KSM Open Pit Design Review

June 12, 2012
Project No: 0683-013-30

Re: KSM Project 2012 Pre-Feasibility Study Update - Open Pit Design Review

BGC ENGINEERING INC. AN APPLIED EARTH SCIENCES COMPANY	REPORT TITLE: KSM PROJECT 2012 PRE-FEASIBILITY STUDY UPDATE OPEN PIT DESIGN REVIEW	
	FIGURE TITLE: MITCEHLL PIT - SECTION A NORTH	
CLIENT: SEABRIDGE GOLD INC	PROJECT No.: 0638-013-30	FIGURE No.: A-1

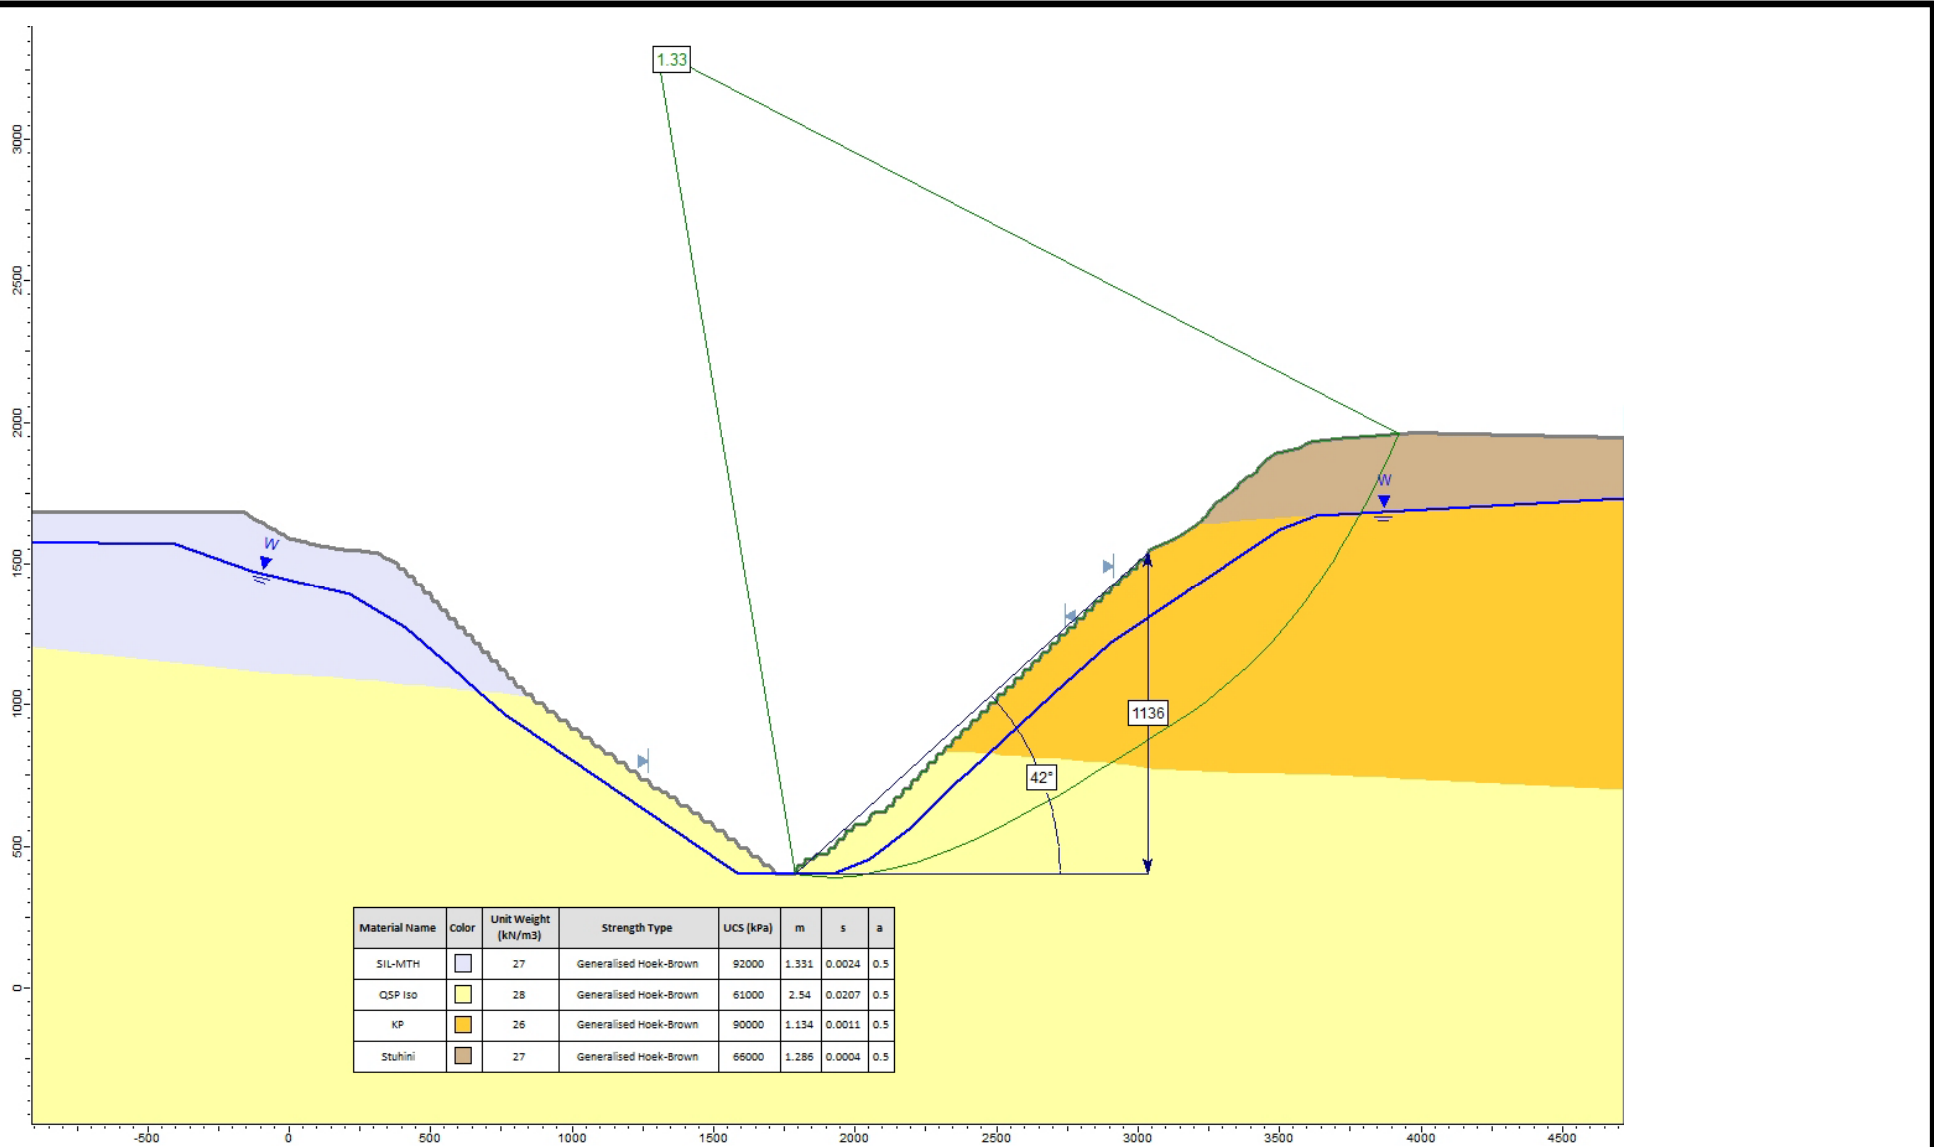
The FOS for the North portion of Section A is 1.3, assuming a water table set back 150 m from the pit face in Domain I and 200 m in Domain II. As a result of the reduction in the ultimate wall height of the north slope of the Mitchell pit, the minimum water table setback in Domain II required to achieve the design FOS has been significantly reduced from the 350 m previously estimated for the previous pit geometry. The configuration of the overall slope of the north wall is controlled by the requirement to limit the potential for instability of the overall slope.

FIGURE TITLE:
MITCEHLL PIT - SECTION A SOUTH

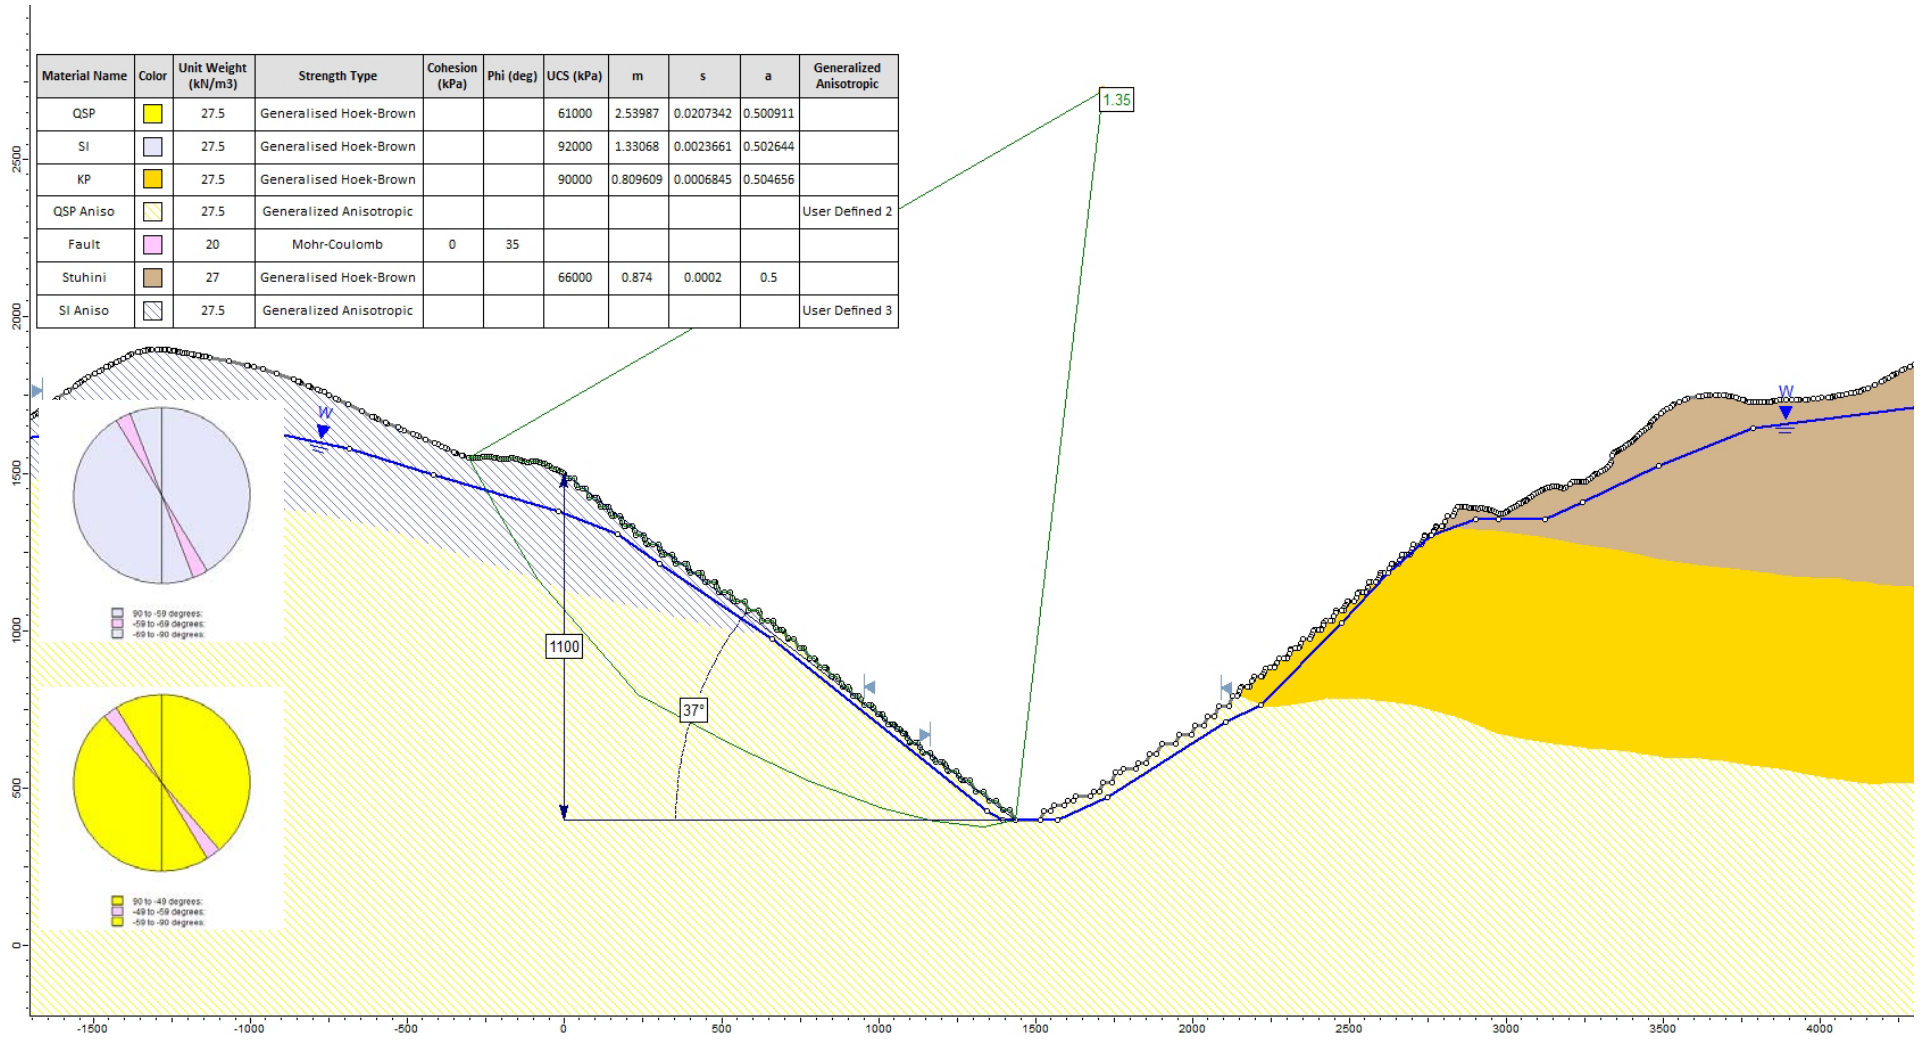
The overall FOS for the South portion of Section A is 1.5, assuming a water table set back 50 m from the pit face to depressurize the inter-ramp scale slopes can be achieved. The configuration of the overall slope of the south wall is controlled by the requirement to limit the potential for inter-ramp slope scale instabilities related to geological structures.

FIGURE TITLE:
SULPHURETS PIT – SECTION H

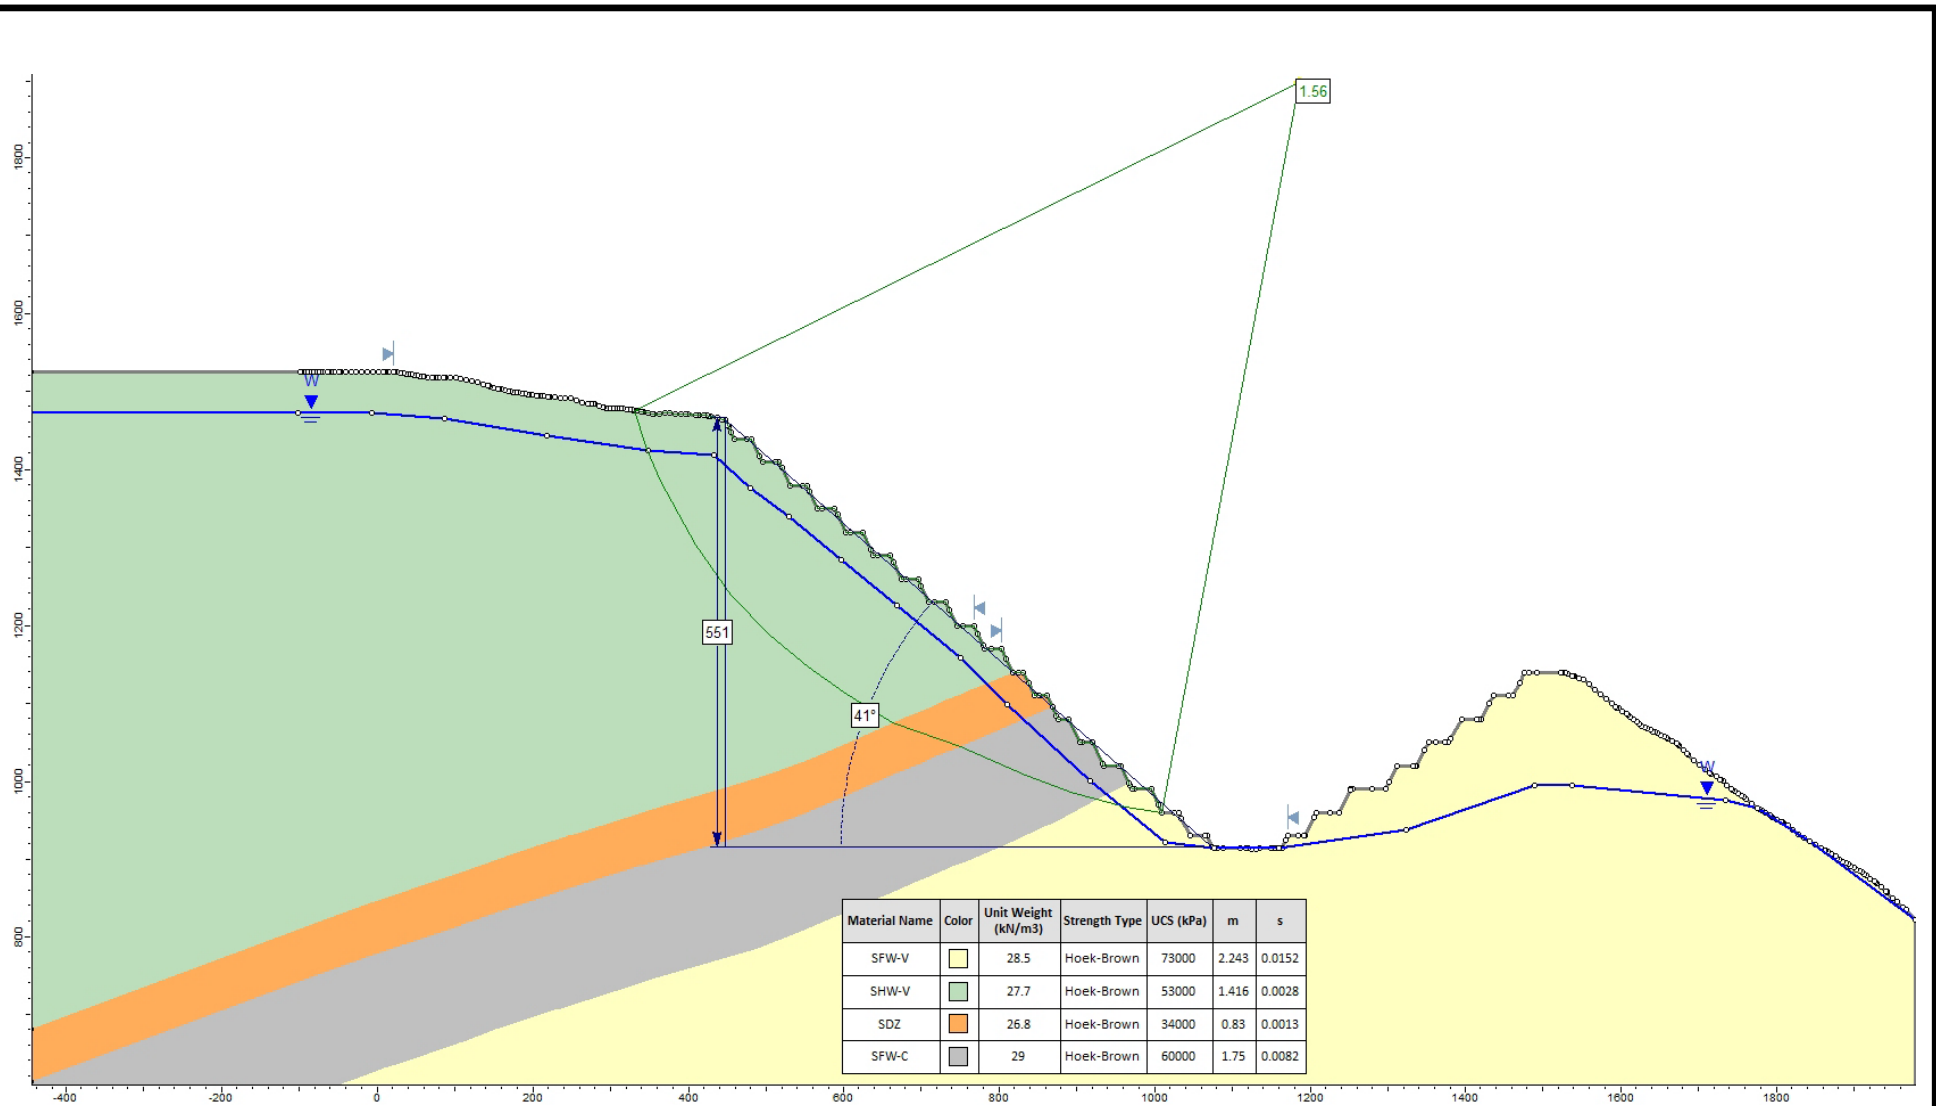
The overall FOS for Section H is 1.6, assuming the water table is set back 50 m from the pit face. The overall FOS for Section I is 1.4, assuming the water table is set back 50 m from the pit face. The configuration of the overall slope on both sections is determined by the requirement to limit instability due to geological structures at the inter-ramp slope scale. The 50 m set back of the water table is required to depressurize the controlling geological structures. The overall slope geometry and the global minimum failure surface for each section are shown in Appendix A.

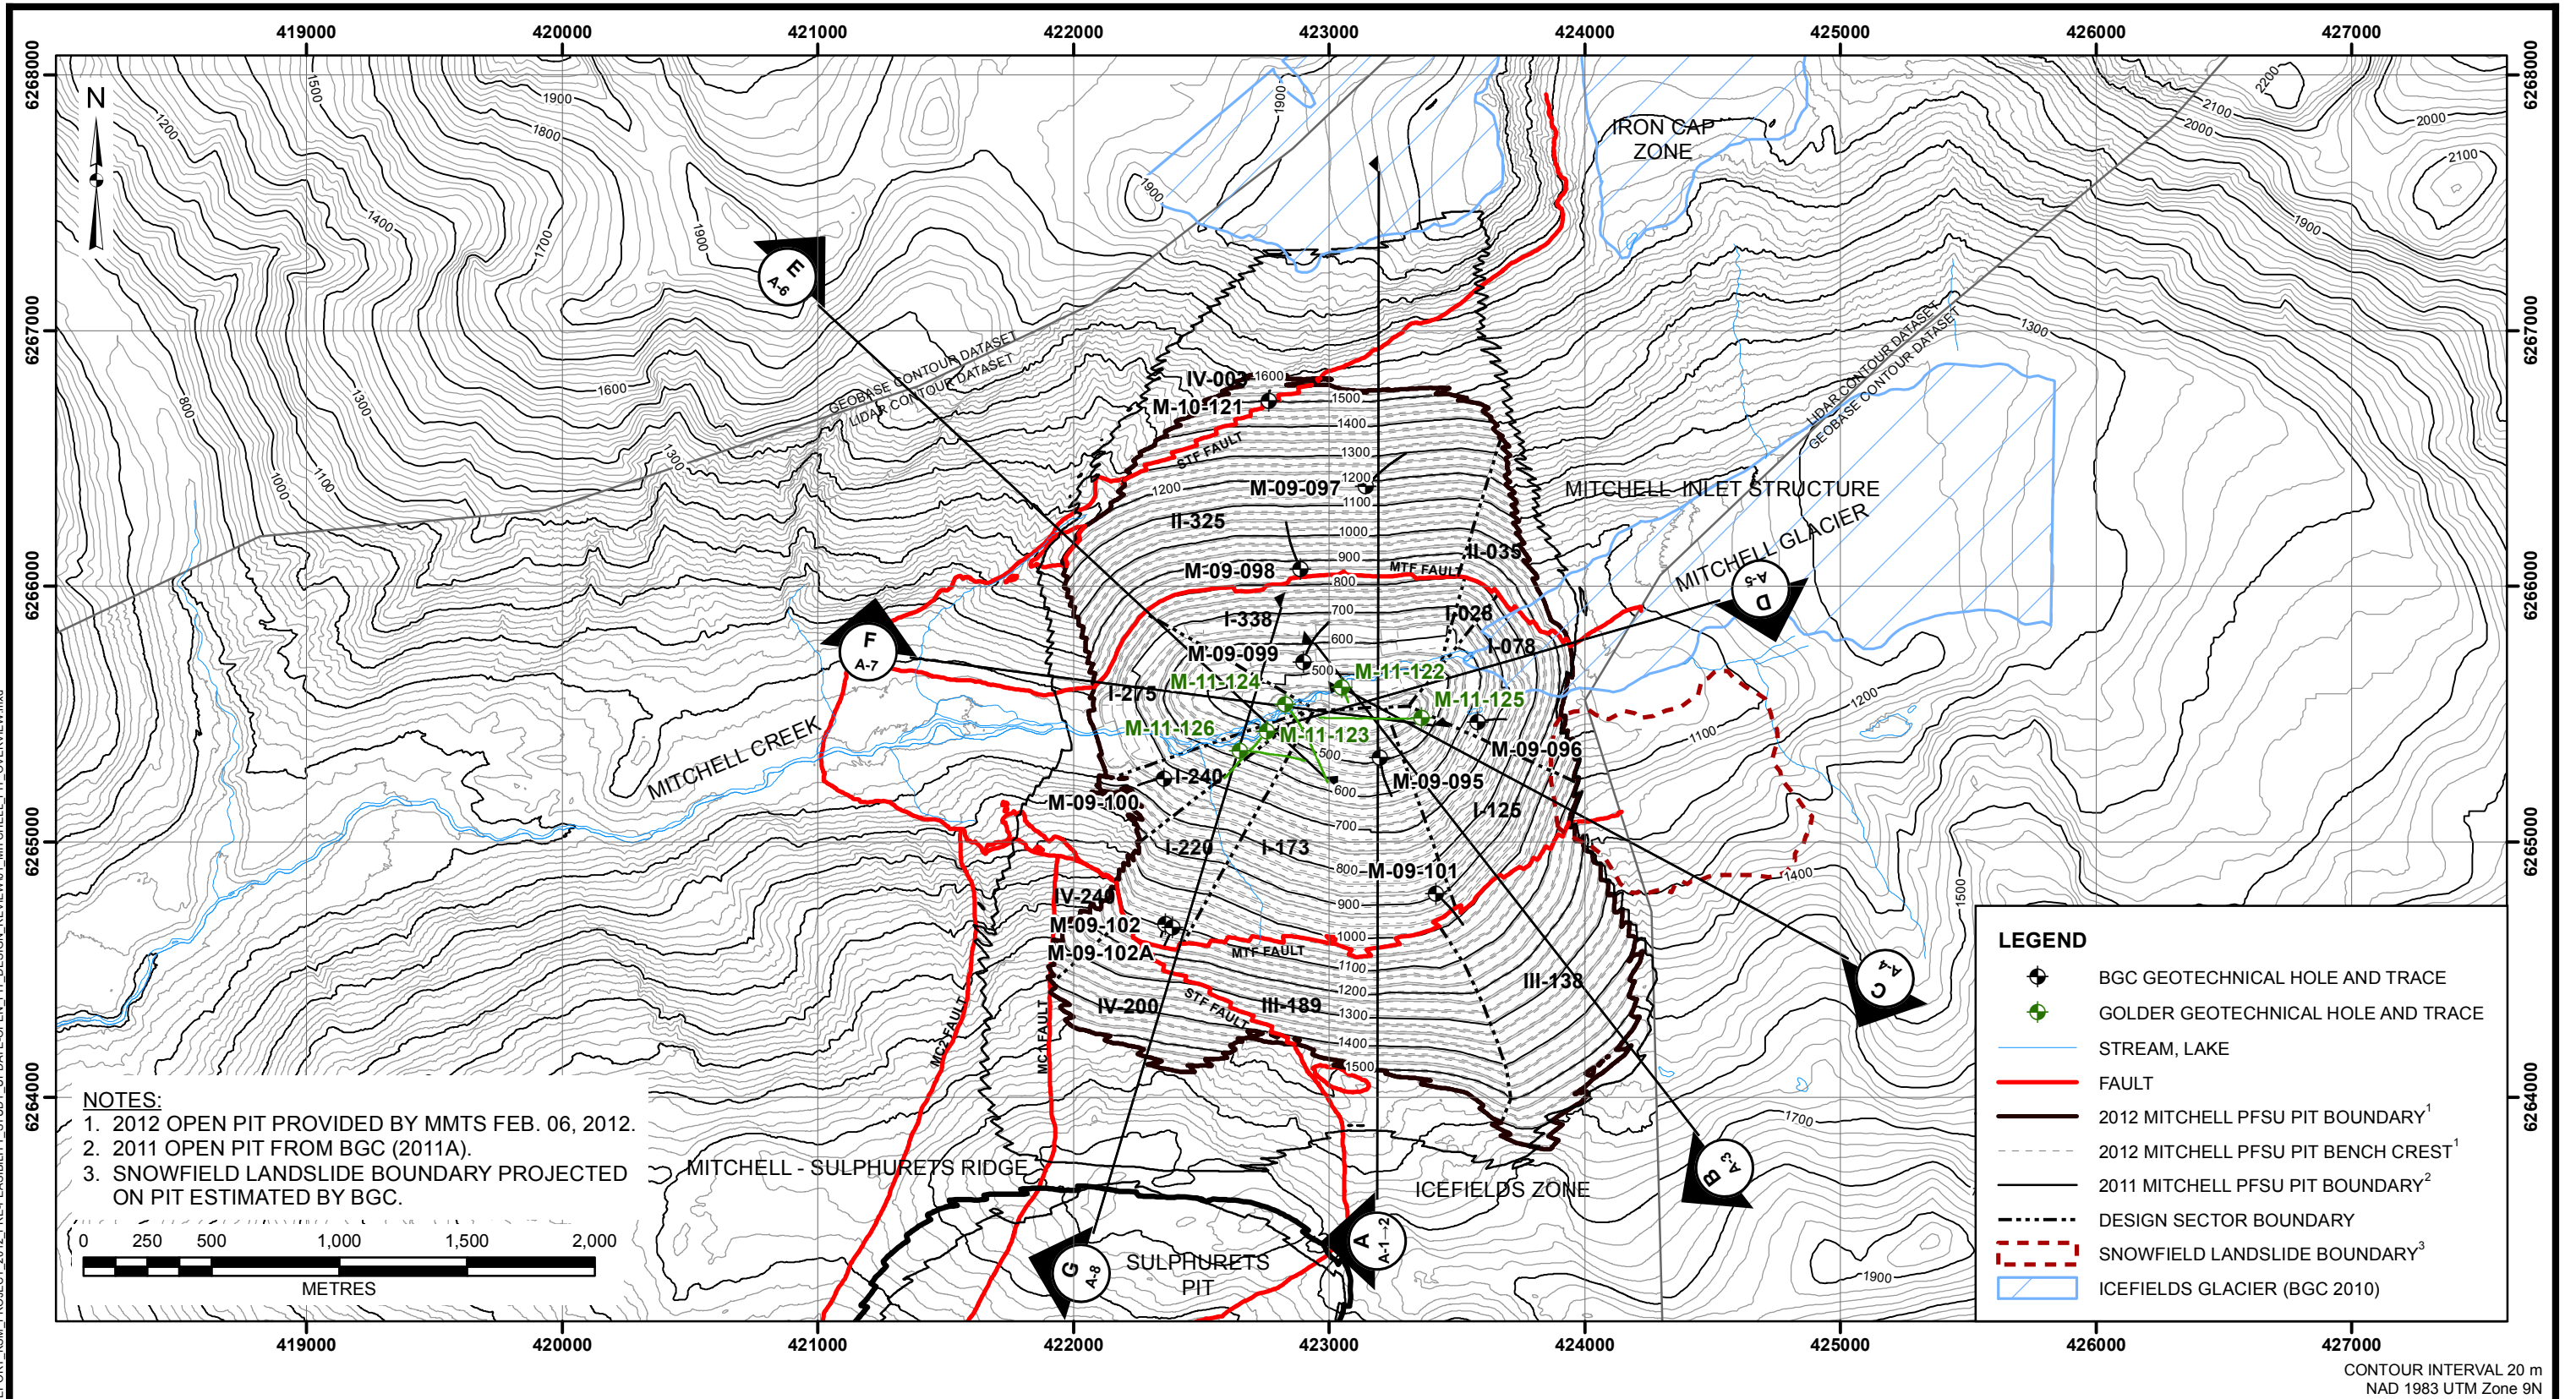
The Mitchell zone is the largest deposit of the KSM project. The target zone is located in the Mitchell Creek Valley, immediately downstream of the Mitchell Glacier (Drawing 1). The proposed Mitchell ultimate (final phase) open pit geometry has changed significantly from the last stage of study due to the addition of a block cave below the ultimate pit. The total mined height of the north wall has been reduced from 1,650 m to 1,200 m. Consequently, the heights of the other final walls have also been reduced (Drawing 1).

An initial review was completed for the M685 ultimate pit, as provided in the file "Mitchell pit phases MMTS.dxf" to BGC by MMTS on January 11, 2012. The review identified two sectors in the southeast and southwest corners of the pit where the design inter-ramp / interberm slope angles were exceeded; BGC communicated the results of this review to MMTS by email on January 19, 2012. Based on this review, MMTS developed an updated M685 ultimate pit and provided the file "m685 ultimate pit.dxf" to BGC on February 2, 2012. Our review of the updated M685 (Drawing 1) ultimate pit indicates that it meets all of BGC's slope design geometry requirements (BGC, 2011a).
